RE: Addendum #1 to the May 25, 2001 Comprehensive VOC Investigation Work Plan for The Lockformer Company, Lisle, Illinois.

Mr. Stan Komperda
IEPA
Comprehensive VOC Work Plan Addendum #1

Clayton Project No. 15-65263
July 16, 2001
Page 3

Clayton
GROUP SERVICES
3140 FINLEY ROAD, DOWNERS GROVE, IL 60515
FIGURE 4

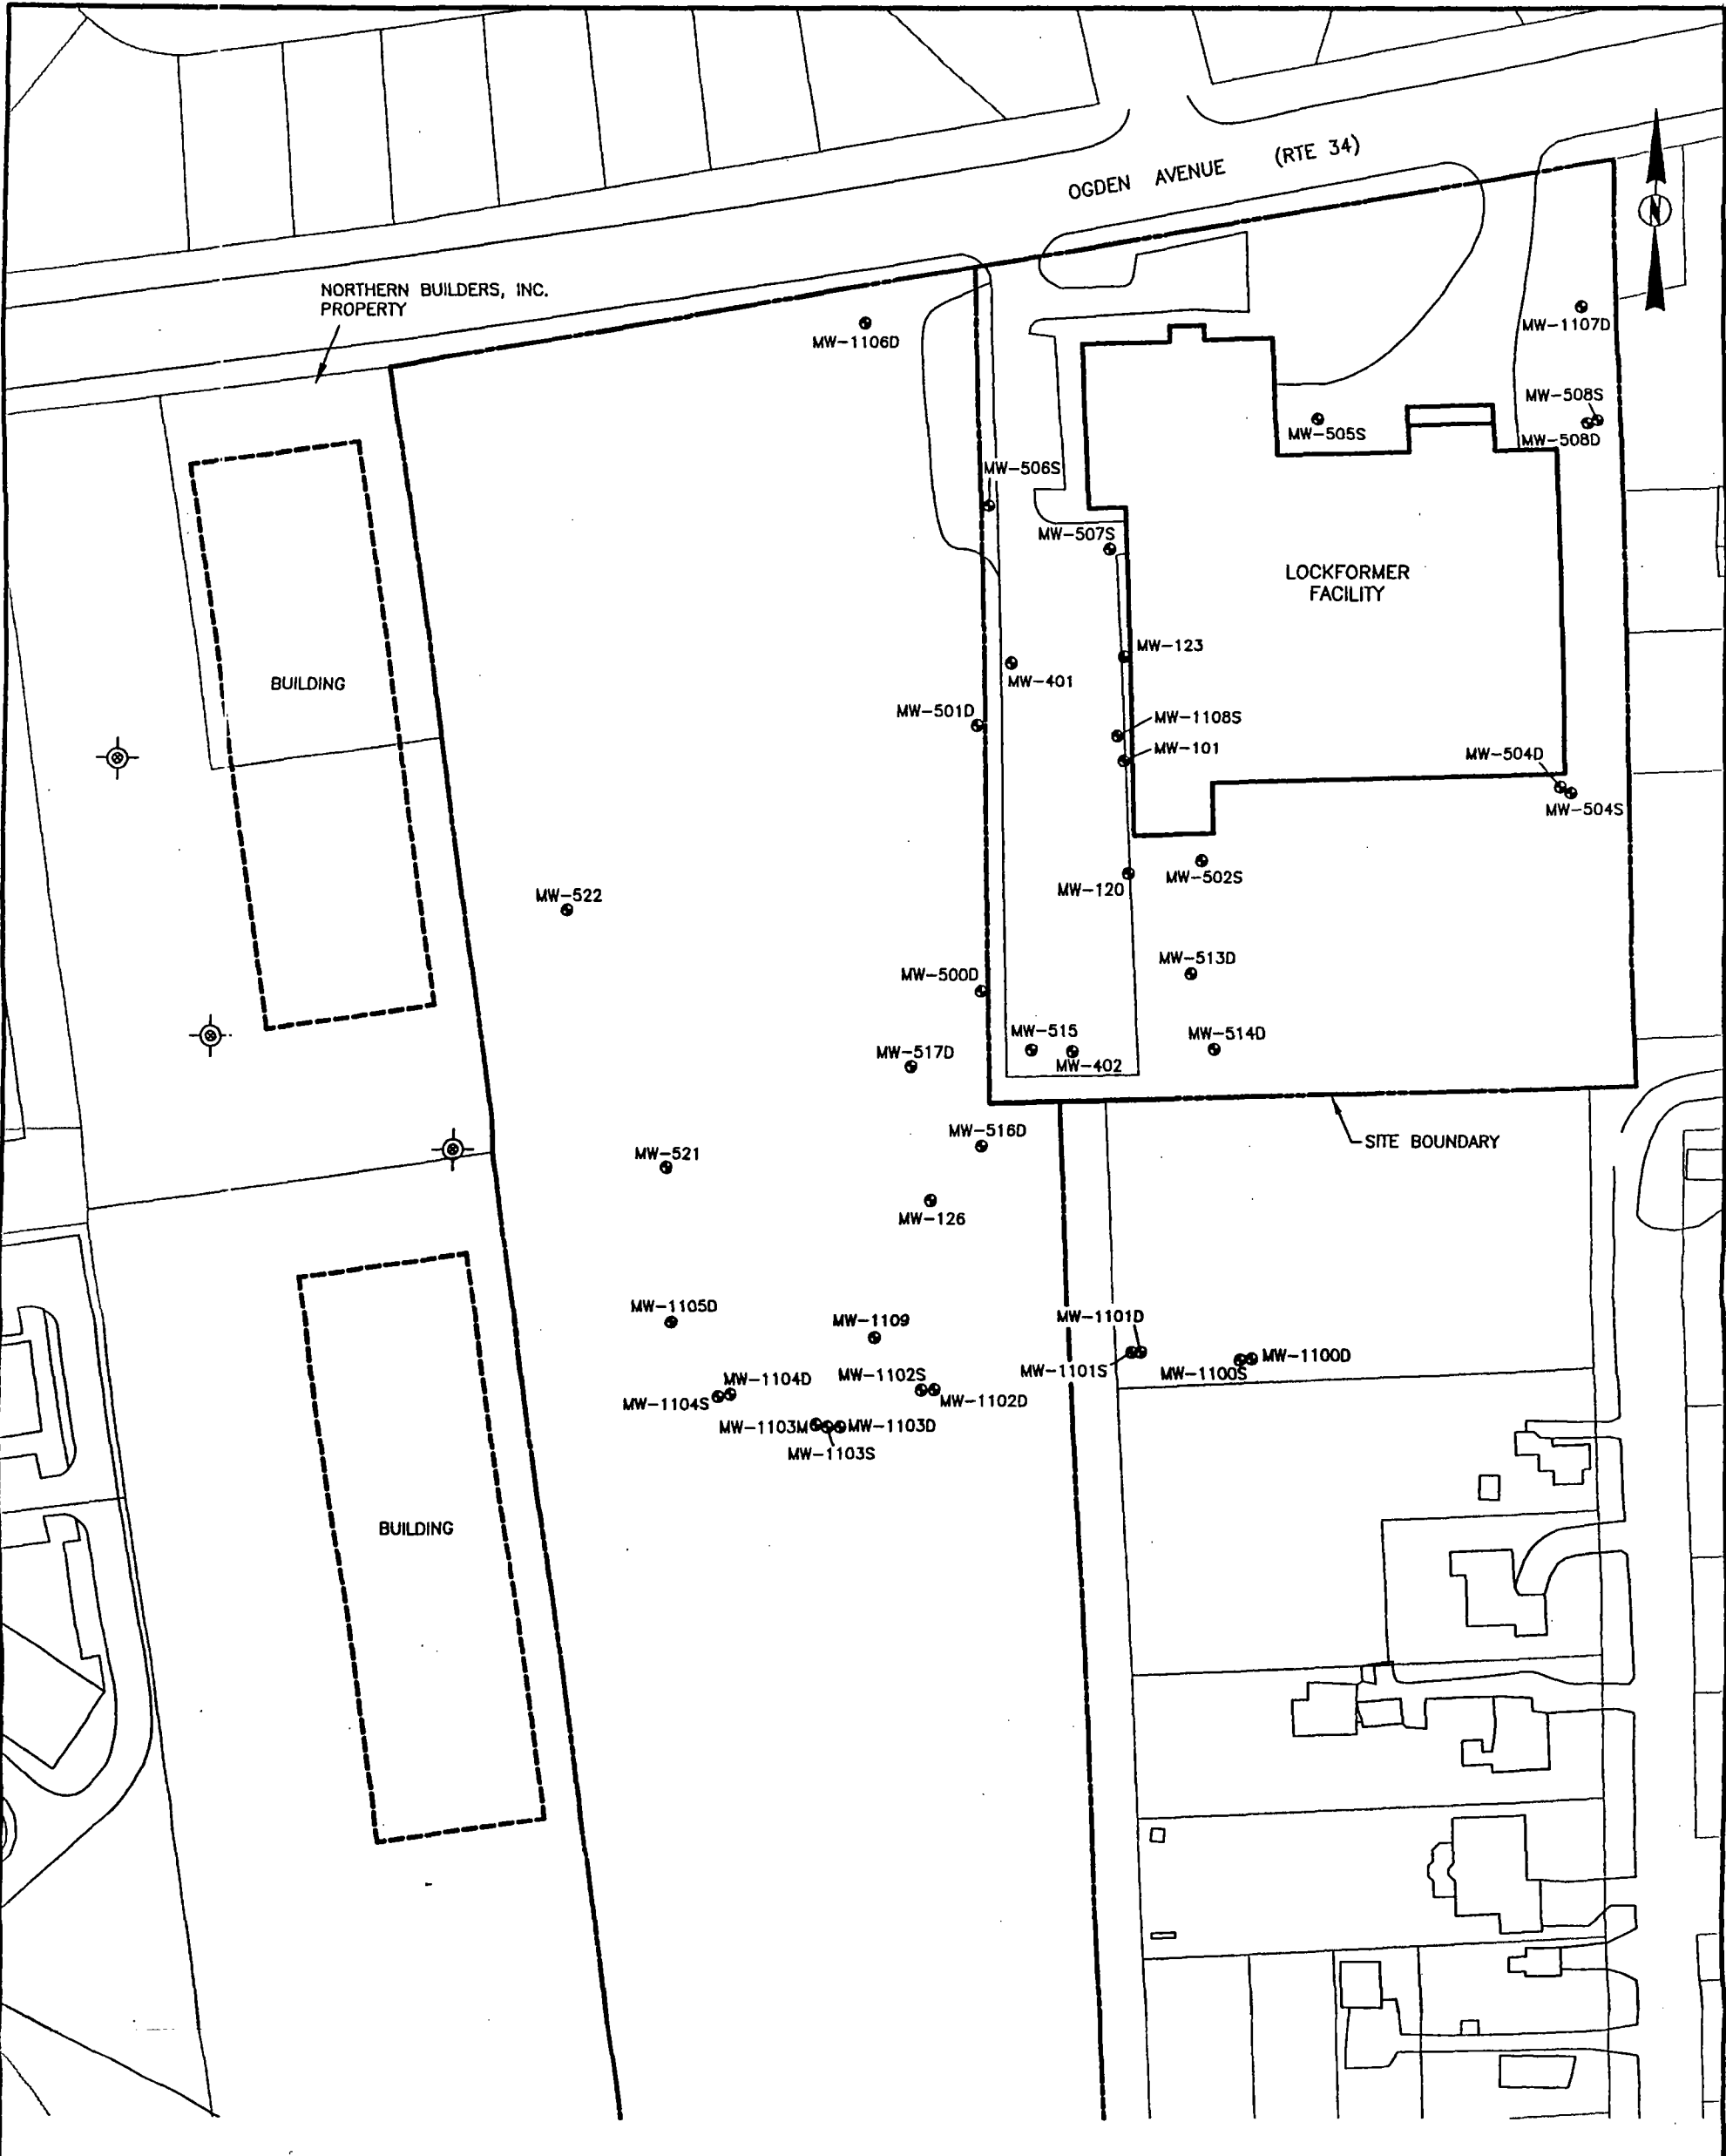
3. All monitoring wells that Lockformer has direct control over will have their static water levels acquired during the same day. Other wells (e.g., public water supply wells) that Lockformer does not have direct control over will have their static water levels determined in as close to a synoptic manner as possible.
4. The level at which the pump will be set during the pump test to take place on monitoring well MW-1102D will be determined during testing that will be performed prior to the pump test actually taking place. This pre-testing will be performed to determine the maximum sustainable yield of the formation for the pump test.
5. An updated Figure 4 is provided with this letter.
